TITLE: AIR CONDITIONING - PACK TEMPERATURE CONTROL - INSTALL PACK TEMPERATURE

CONTROLLER PN 759C0000-03

MODIFICATION No.: 34732K9632

This page transmits Revision No. 01 of Service Bulletin No. A320-21-1151.

Figure 3, Sheet 1 Config. 01 thru 02 : Removal and Installation of Pack Temperature Controllers 7HH and 27HH

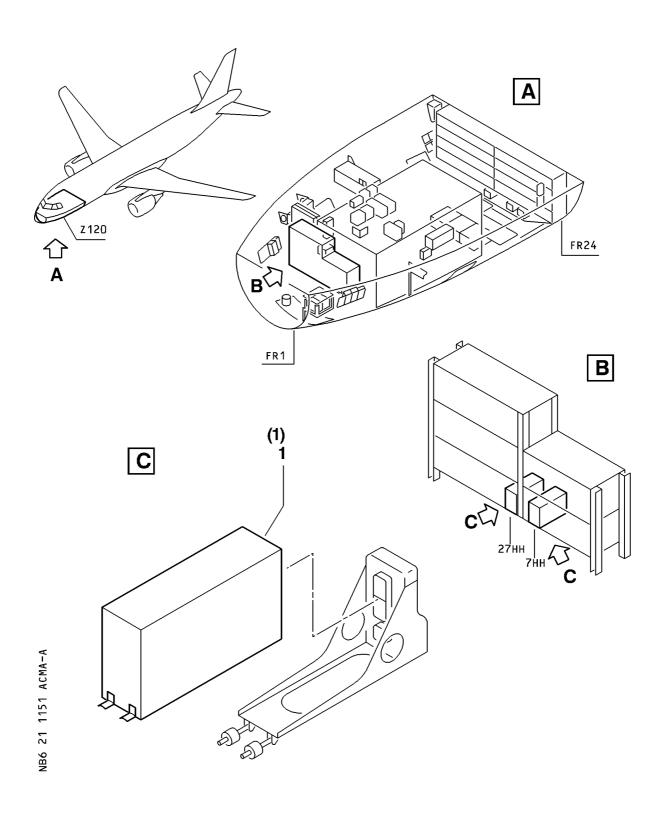
- (e) Modify and replace the pack controllers 7HH and 27HH. Refer to Figure 3
 - Do the modification to the retained pack controllers, Item (1), refer to LIEBHERR-AEROSPACE LINDENBERG Service Bulletin No. 759A-21-09.
 - Reidentify the controllers 7HH and 27HH, refer to LIEBHERR-AEROSPACE LINDENBERG Service Bulletin No. 759A-21-09.
 - 3 Install the controllers 7HH and 27HH, refer to AMM 21-61-34, Page block 401.

(a) Replace the pack controllers 7HH and 27HH. Refer to Figure 3

Figure 6, Sheet 1

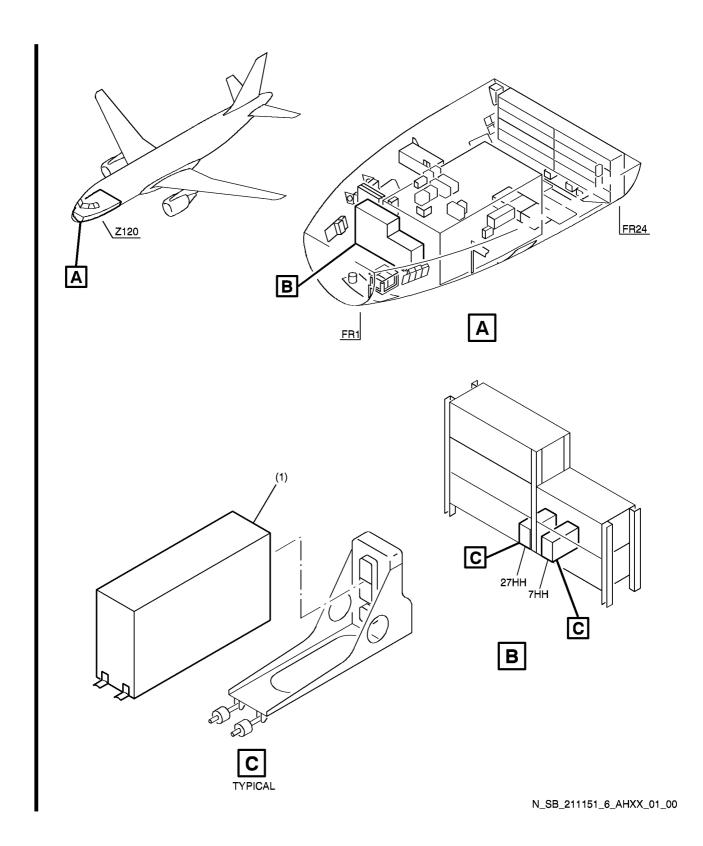
<u>a</u> Remove and retain the pack controllers 7HH and 27HH from the avionics compartment.

Refer to Figure 6
